APPLICATION NO.	FILING DATE	FIRST NAMED INVENTOR	ATTORNEY DOCKET NO.	CONFIRMATION NO.
10/542,490	07/15/2005	Benoit Noettinger	612.45186X00	5318
20457 7590 09/25/2007 ANTONELLI, TERRY, STOUT & KRAUS, LLP 1300 NORTH SEVENTEENTH STREET SUITE 1800 ARLINGTON, VA 22209-3873			EXAMINER JONES, HUGH M	
			ART UNIT 2128	PAPER NUMBER
			MAIL DATE 09/25/2007	DELIVERY MODE PAPER

<p align="center">Office Action Summary</p>	<p>Application No.</p> <p align="center">10/542,490</p>	<p>Applicant(s)</p> <p align="center">NOETINGER ET AL.</p>	
	<p>Examiner</p> <p align="center">Hugh Jones</p>	<p>Art Unit</p> <p align="center">2128</p>

DETAILED ACTION

Figure 9. Rayleigh-Taylor instability on a 64×256 grid using the front-tracking algorithm.

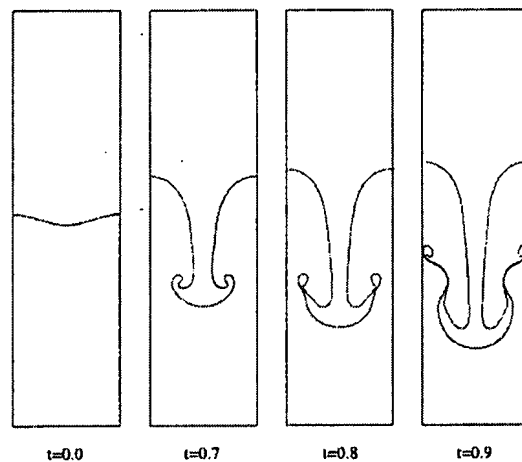
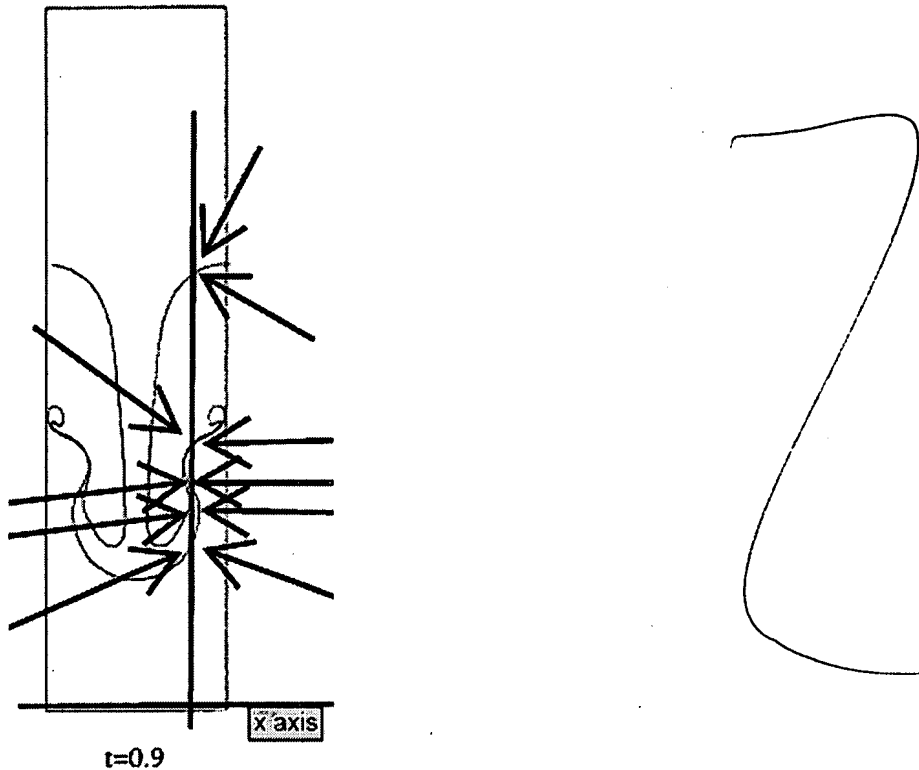
8. The first three limitations were not described in the specification in such a way as to enable one skilled in the art to which it pertains, or with which it is most nearly connected, to make and/or use the invention. Consider the following *realistic* example of an interface (fig. 9 of Popinet et al.):

Assume for the sake of argument that the interface corresponding to $t=0.9$ is taken to be the *a priori* interface. The interface for $t=0.9$ is reproduced; this time with arrows indicating all interfaces for a selected point (on the x axis):

9. Note, for this example, that there are five interfaces. The specification does not address such situations. The specification does not teach how to:

- provide for the *a priori* interface for any but the simplest situations (for example, what if the interface corresponding to $t=0.9$ is taken to be the *a priori* interface?);
- determine pressures on both sides of the *a priori* interface (the standard pressure equation) for any but the simplest cases;
- iteratively change the form of the interface until pressure equalization occurs for any but the simplest cases;

- set a "zone" for complex geometries (or any interface). In the situation in the above figure, the concept of "zone" appears to lose meaning.
10. The specification does not disclose whether stationary pressure equalization will actually occur, due to Rayleigh-Taylor instabilities. It also appears that if the initial interface is stationary, that the pressure would already be inherently equalized.
